CITY OF TAYLOR, TEXAS

PLANNING AND ZONING COMMISSION MEETING

May 10, 2022, 6:00 P.M.

Staff has completed its review of plat for the RCR-Taylor Logistics Park Phases 1, 2 & 3 Preliminary Plat that is to be located at 201 FM 3349, Taylor, TX 76574. There are some corrections that need to be made prior to approval of the preliminary plat. Your plat application will be placed on the May 10, 2022, agenda for the Planning and Zoning Commission meeting. Comments from this review follow.

RCR-TAYLOR LOGISTICS PARK

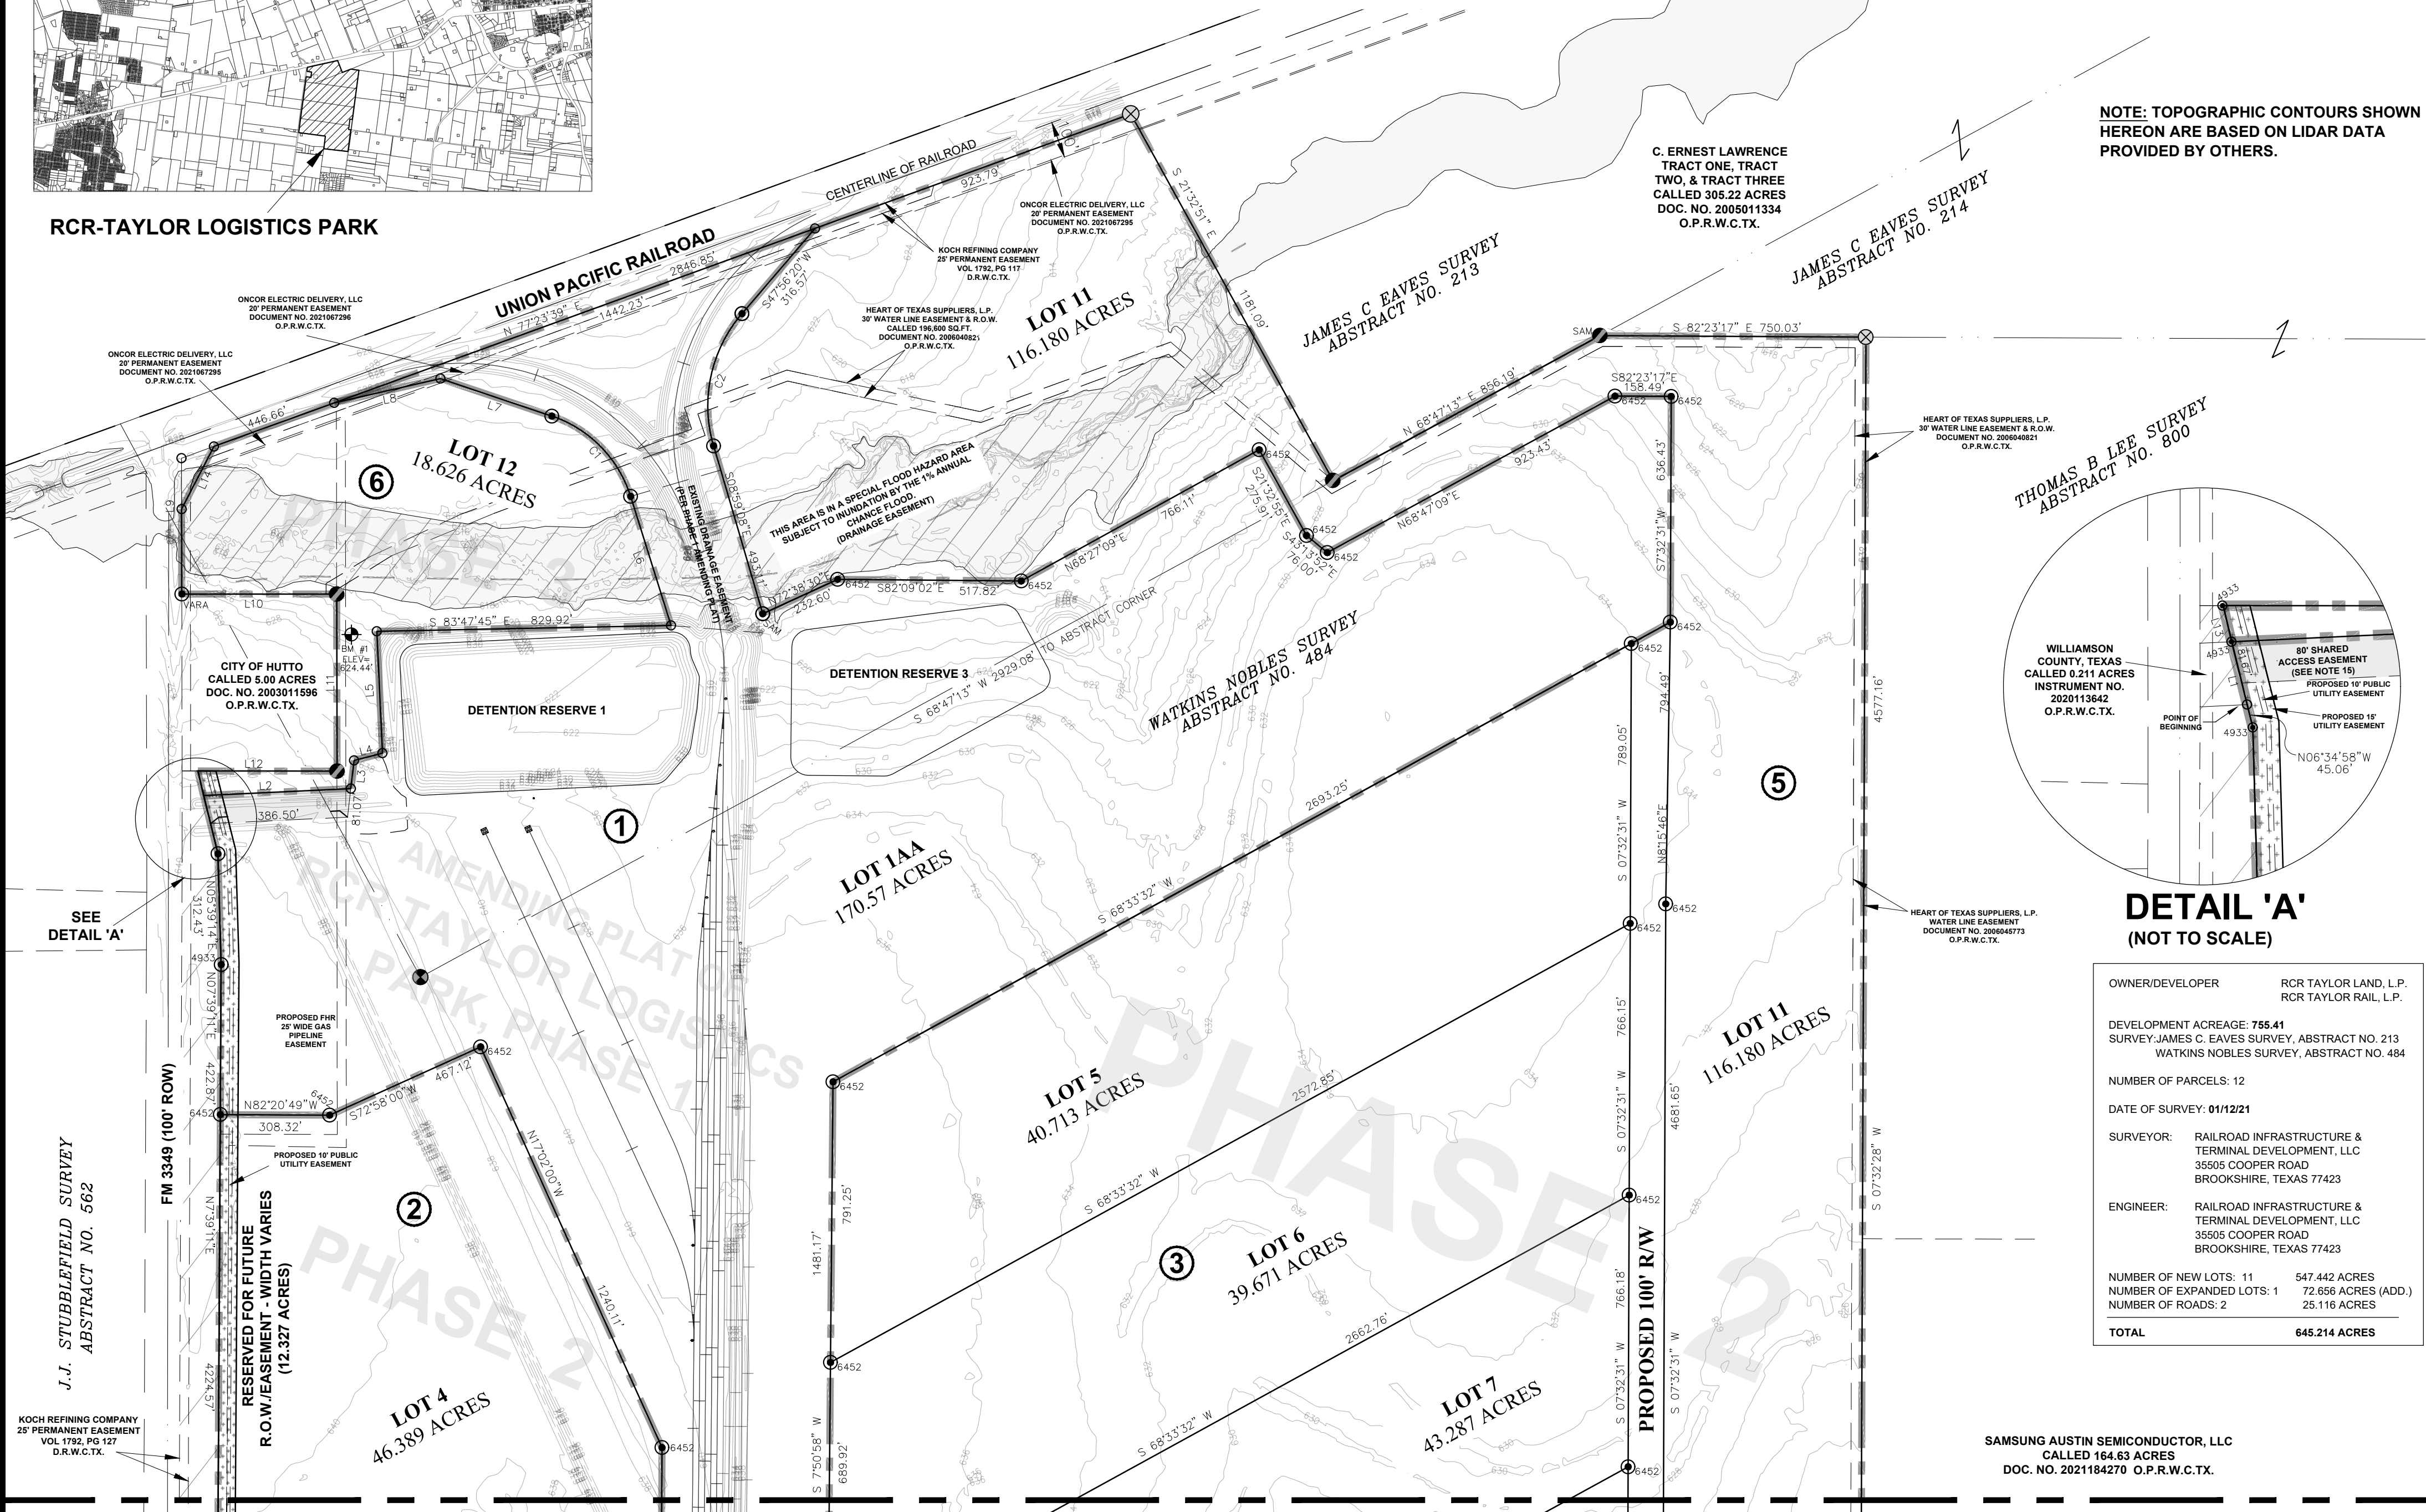
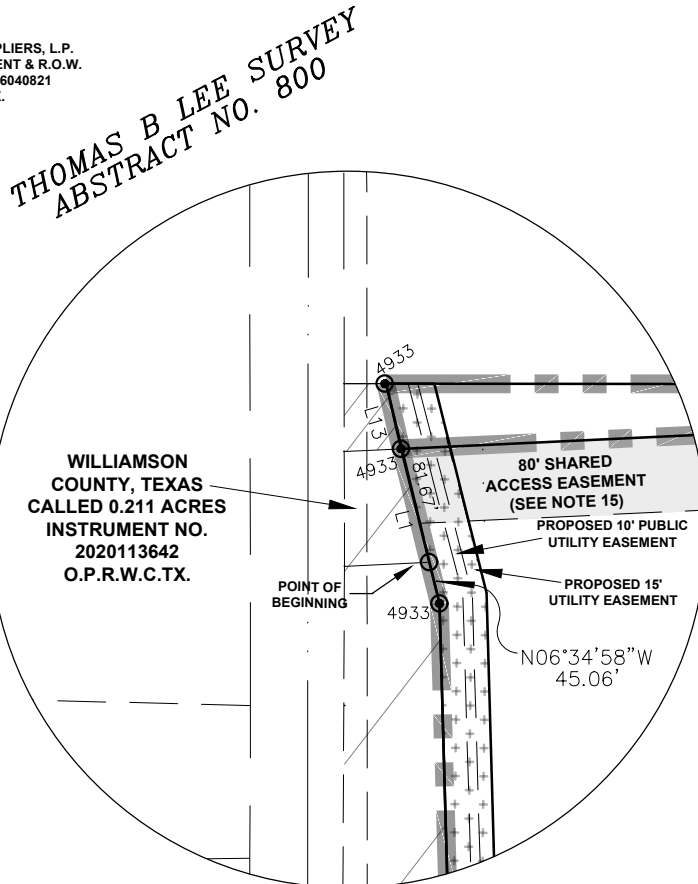
2. The preliminary plat and zone layout need to be consistent with each other.
3. The new street design needs to be approved prior to resubmission.
4. Show on the prelim that the Flint Hills easement will be relocated so the drainage easement will not cross it.
5. Verify Flint Hills has reviewed and approved the placement of the RCR drainage easement overlapping the Flint Hills Easement. See ordinance excerpt below:

6. Provide preliminary plans showing utility extension based on the City plans for wastewater extension.

7. Show sidewalks adjacent to proposed rights-of-way. If sidewalks are not to be provided then that must be proposed in an updated Planned Development ordinance. See ordinance excerpt below:

11. Provide the revision dates.
12. Update the plat information in the table on Sheet 1. See the mark up of Sheet 1 uploaded to the Review Files.
13. Darken the water marks with Phase information, etc. See mark up.

16. East/west CR 404 in the proposed Samsung project has been abandoned so show that on the plat.
17. Explain what will happen at the dead end of the long street going from south to north next to proposed Lot 11.

18. The Title and description of the plat block part of the plat map drawing, please relocate match line.
19. Per Engineering, the discussion regarding access for adjacent properties to the south.
